Date: Oct 08, 1998

To: T10 Committee (SCSI)

From: George Penokie (IBM)

Subject: Persistent Reservations

Figure 1 — Device server interpretation of PREEMPT service action

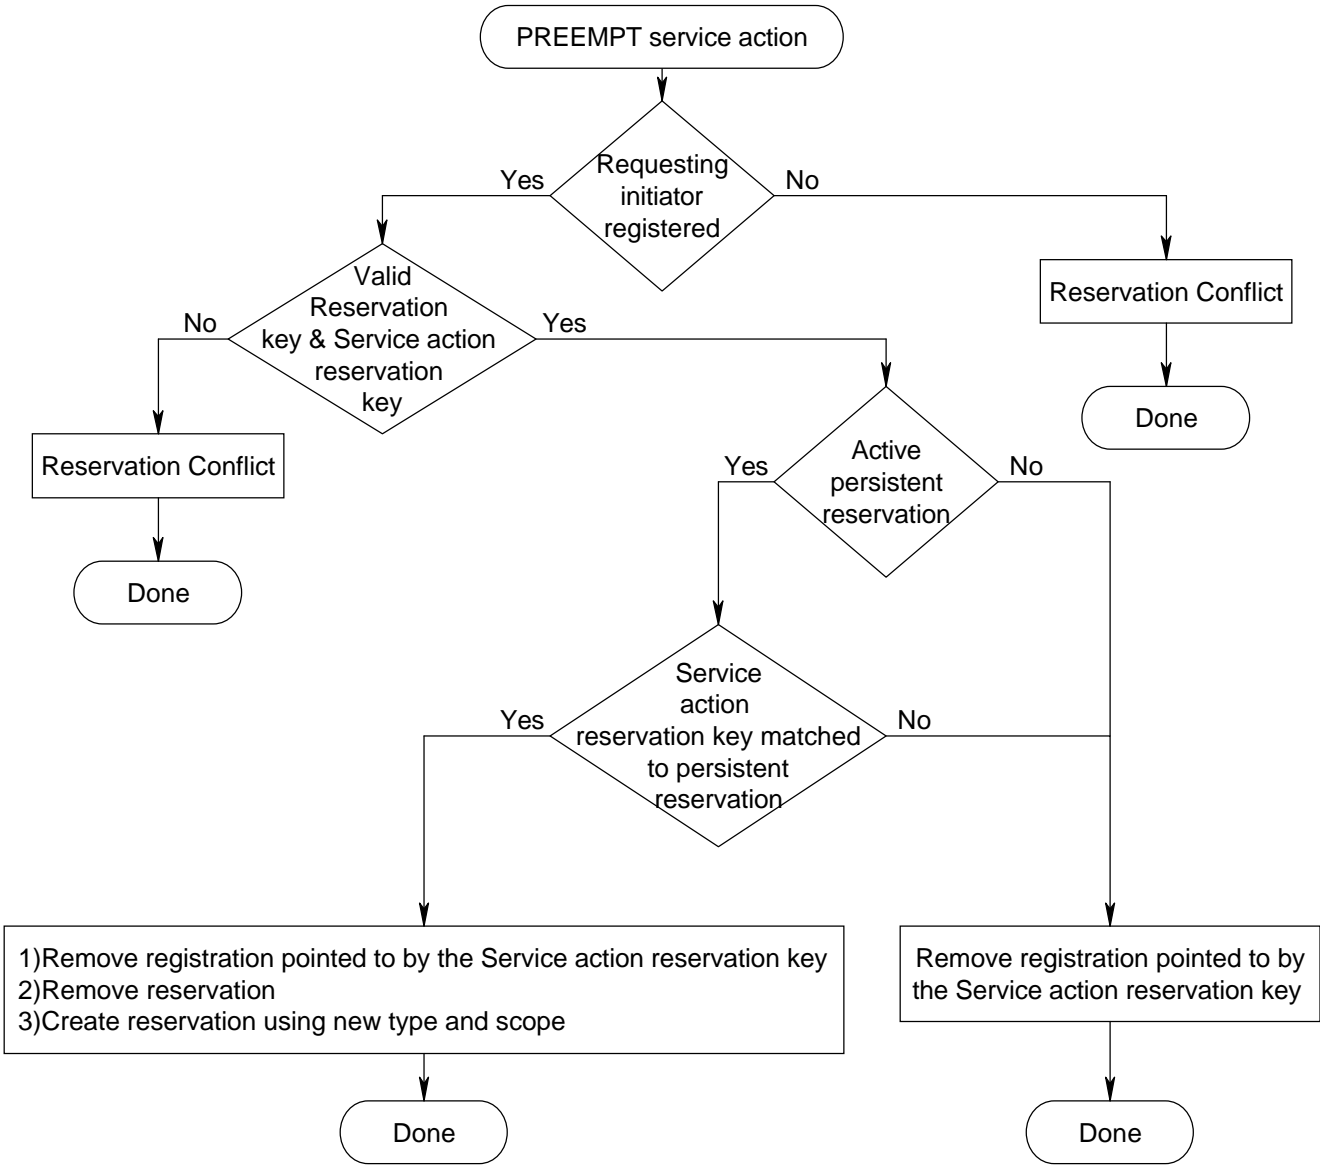
See figure 1 for a description of how a device server should interpret a PREEMPT service action to determine the actions it should take (i.e., preempt persistent reservation, preempt registration or preempt both registration and persistent reservation).
